2033 4TH AVENUE

DESIGN REVIEW MEETING

SDCI #3038668-LU / 6 SEPT 2022

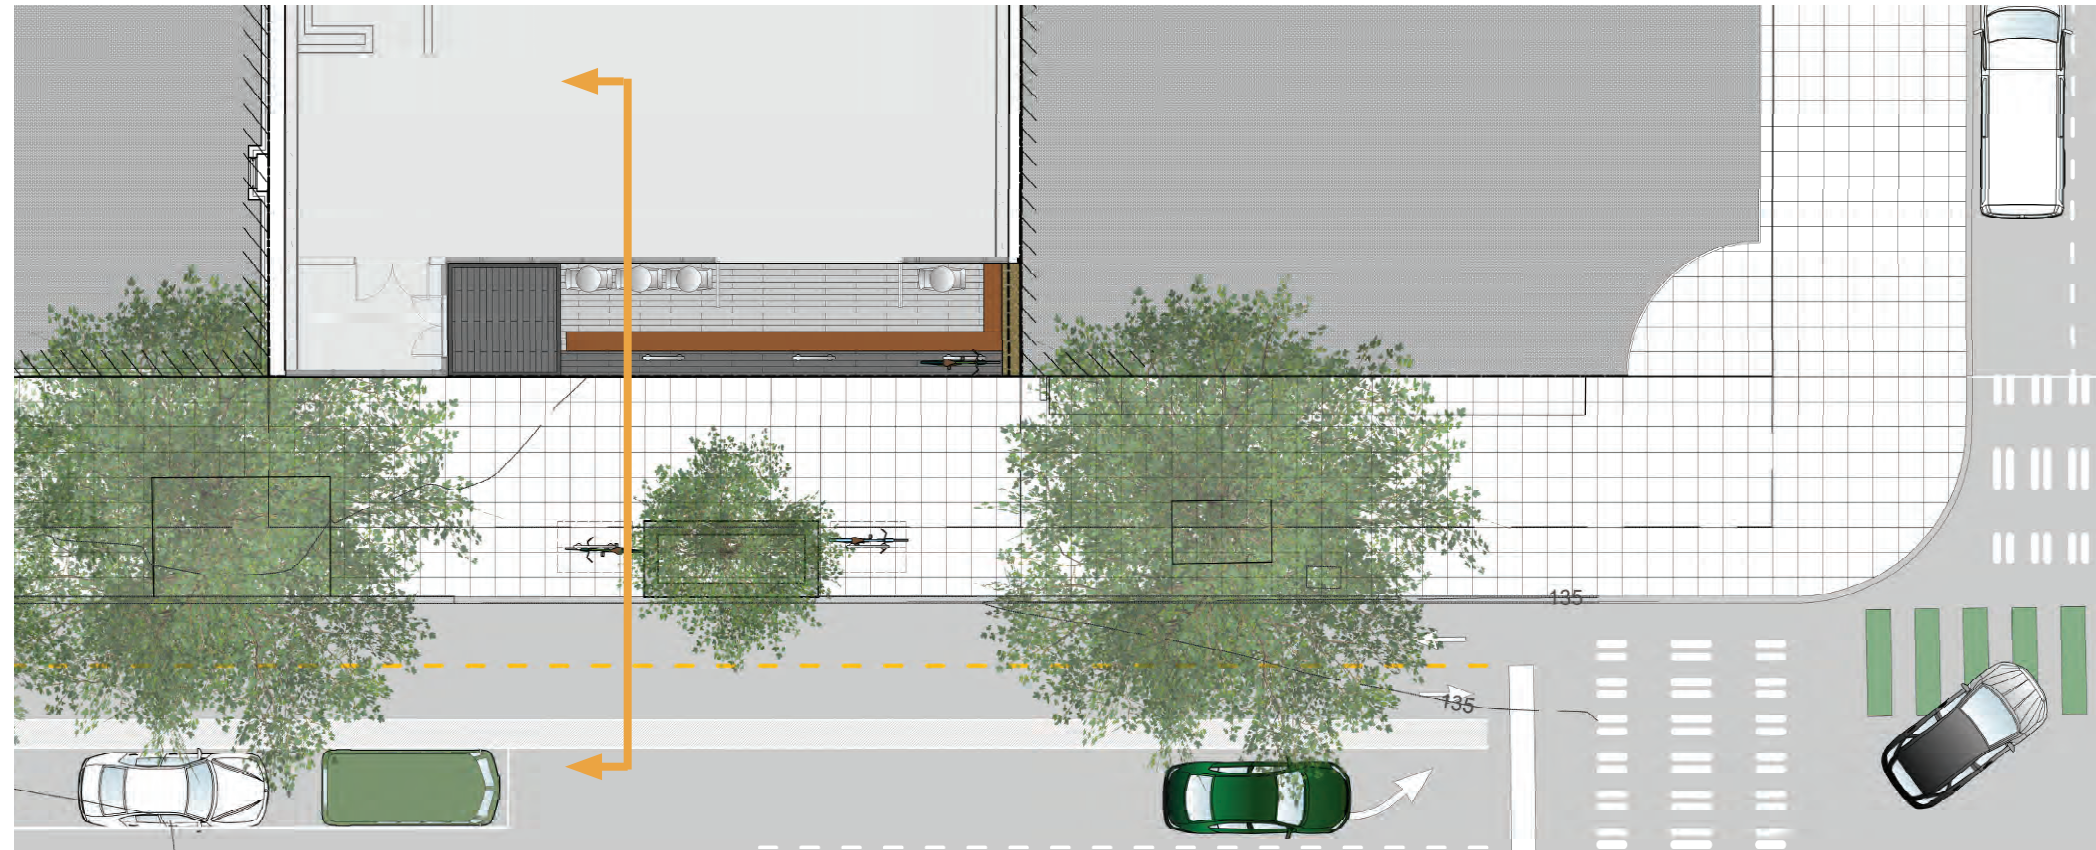
Overhead Weather Protection (SMC 23.49.018): : The Code requires that overhead weather protection shall have a minimum dimension of eight (8) feet measured horizontally from the building wall or must extend to a line two (2) feet from the curb line, whichever is less.

The applicant is proposing to reduce the width of the overhead weather protection by 2 feet to reduce potential impacts to the existing street trees along 4th Ave.

Response: To help keep healthy tree coverage along 4th Ave we propose a 2-0 reduction in the width of the weather protection. The full depth would interfere with the existing street trees.

LEVEL 47 AMENITY PLAN

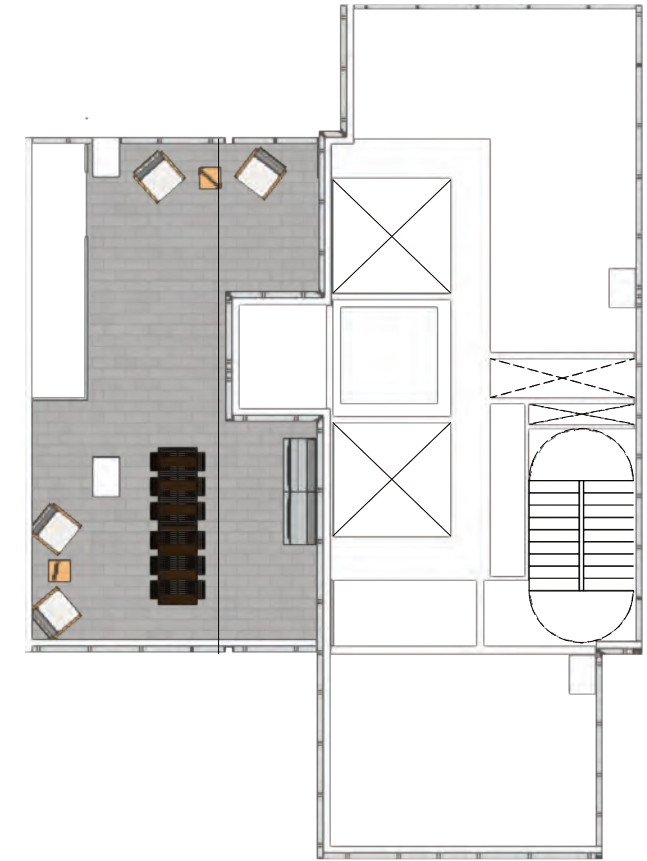
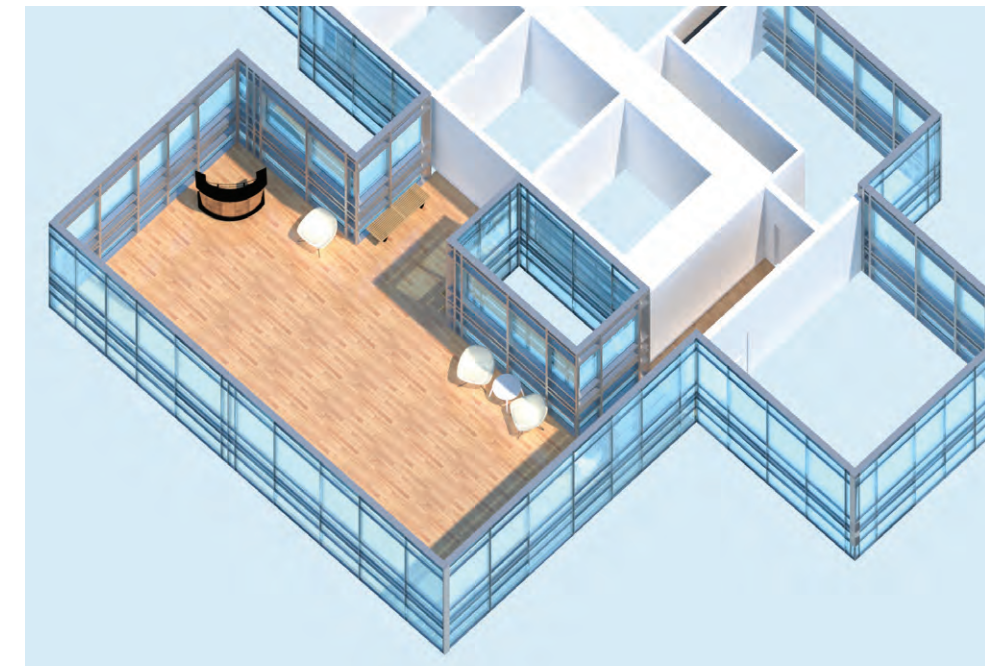
b. The Board reinforced the need to see the integration of rooftop equipment into a seamless building design and not be added as a disorganized afterthought. A.2, A-2.2, B-1.c, B-2.2, B.4, C-2.1, C-3, C-6.C, D-4.4, D-5.c.

The roof top amenity area was modified from the EDG preferred design to wrap the rooftop around the building core. It provides a series of separate spaces that create a sequential change in relation to scale of the users. A covered lanai or porch creates an indoor outdoor relation with the building and provides an outdoor space that can be used year round. This leads to areas covered by arbors that are open to the sky by still provide a human scale to the spaces. The sequence ends in spaces that are open to the sky offering up an experience that allows the residence and users to engage with the unique environment of being hundreds of feet in the air.

CODE COMPLIANT TOWER

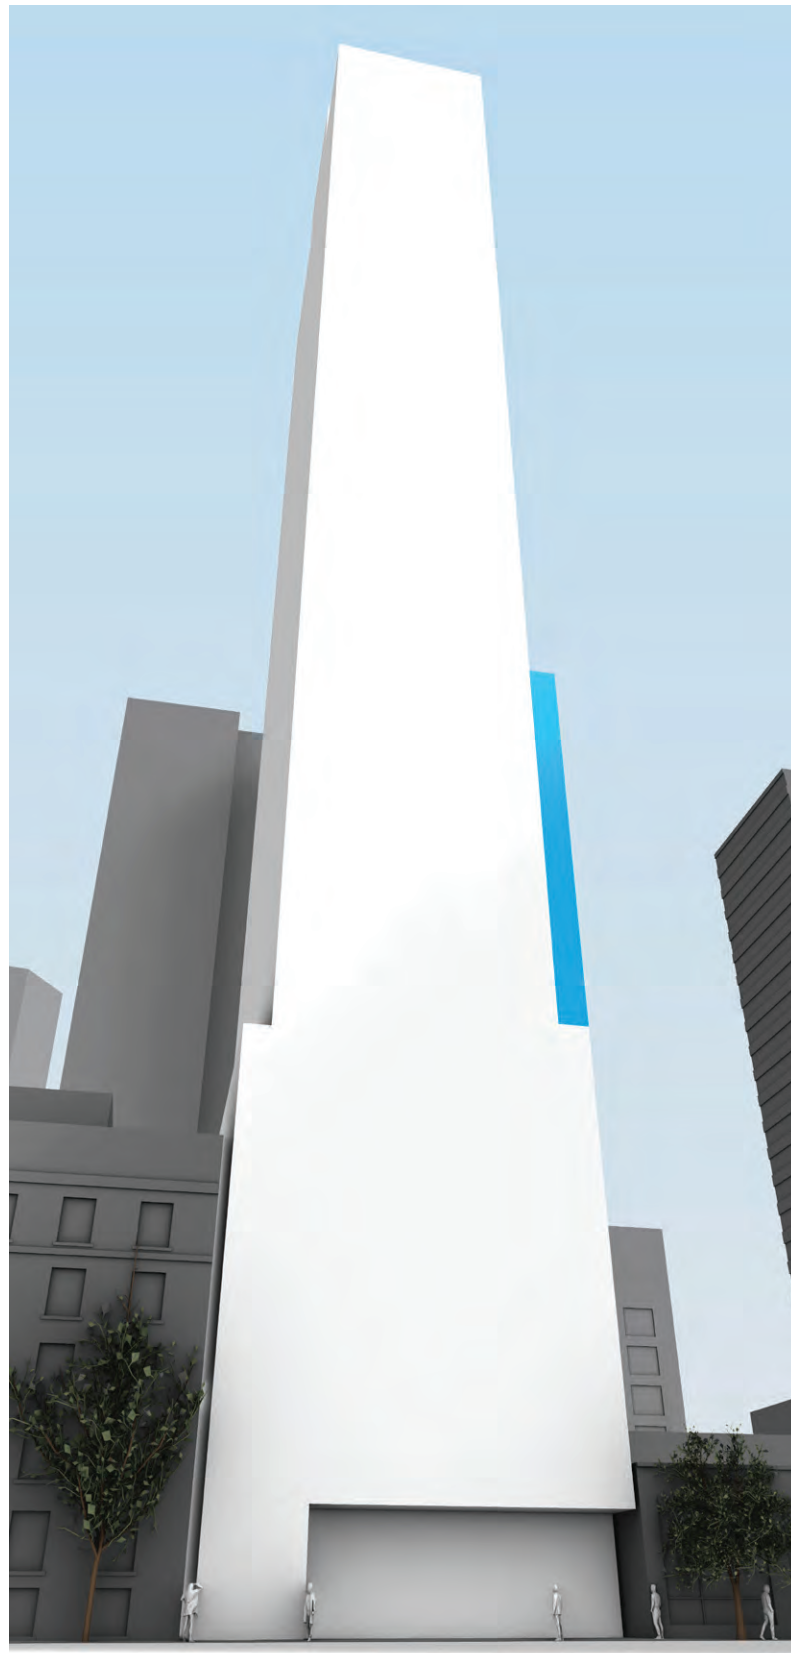
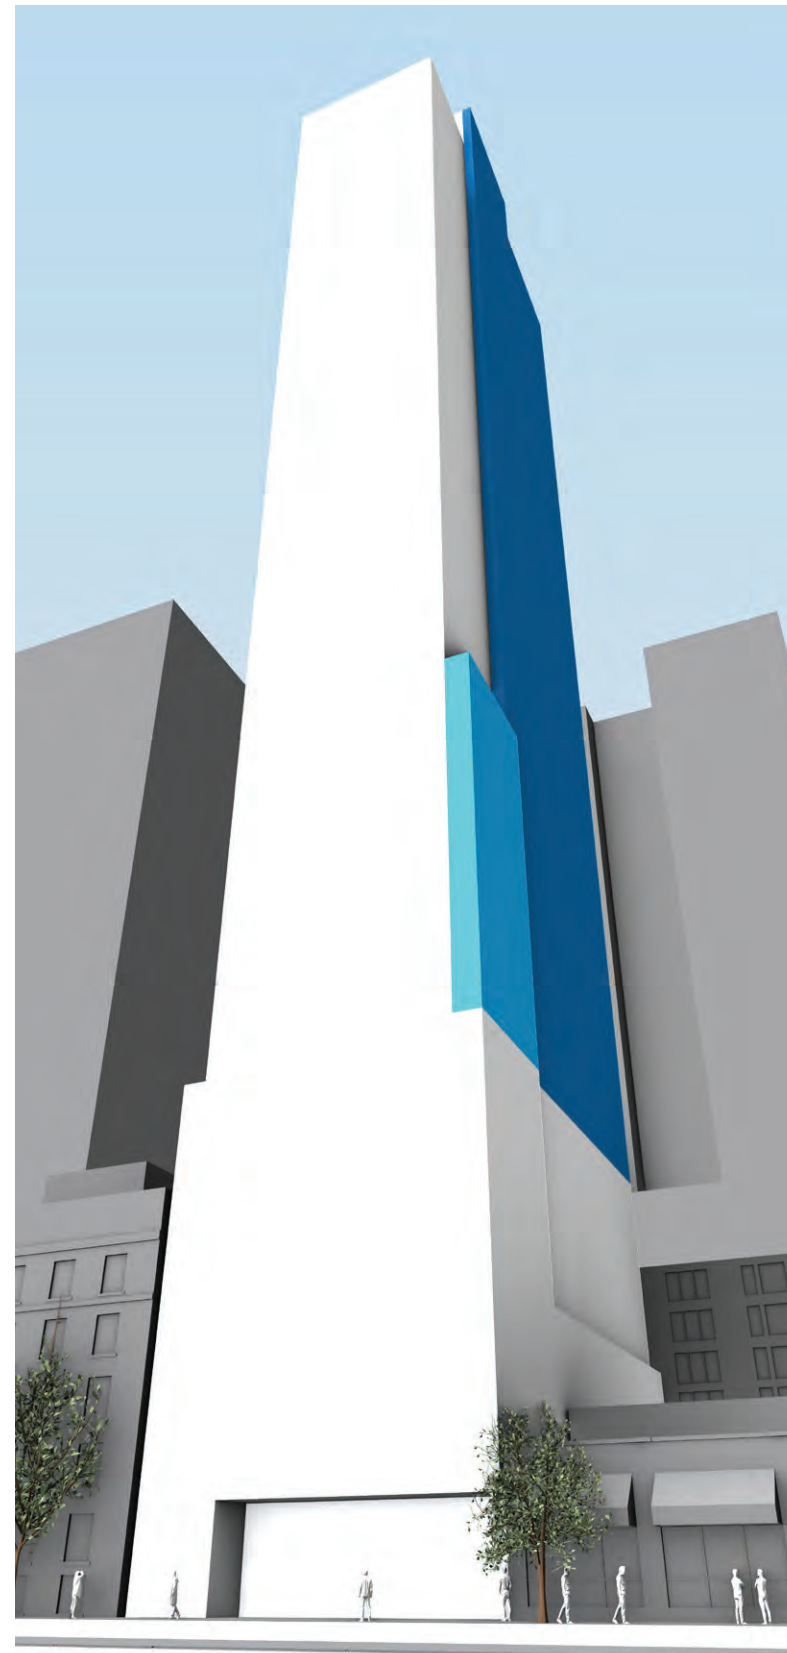
a. The Board did not support this departure as shown in the EDG packet. The Board stated that there are a lot of questions remaining in terms of building fenestration and glazing and that they were not fully convinced that the departure to increase tower width would result in a design that better meets the intent of the Design Guidelines, especially as the design is striving for a slender building expression.

If the applicant continues to request this departure, the Board noted that additional explorations and studies will be required to show how the departure will lead to a design that better meets the intent of Design Guidelines, such as to better conceal the tower core, or accentuate the tower top, better express the slender tower concept, or other design rationale. This information will require clear depictions of the departure in the Recommendation packet, including three-dimensional representation with elevations and sections that demonstrate how the building will result in a better design.

Response: From the Board's recommendation, the design team considered several options, including a code compliant version, as the concept was further developed. In the code compliant option, keeping the tower at the maximum 48' width, the proposal is lovely but it lacks the added detail and complexity of the gentle massing stepping that further empathizes the concept. There is also a lack of modulation and no reduction in bulk - the lot is too small to reduce floor plates as we rise.

The revised preferred concept was strengthened by adding gradient of color, frit pattern development, mullion extensions with a distinct pattern and most importantly, subtler change in the mass of the tower as it rises. This subtle massing trimming helps the tower read as
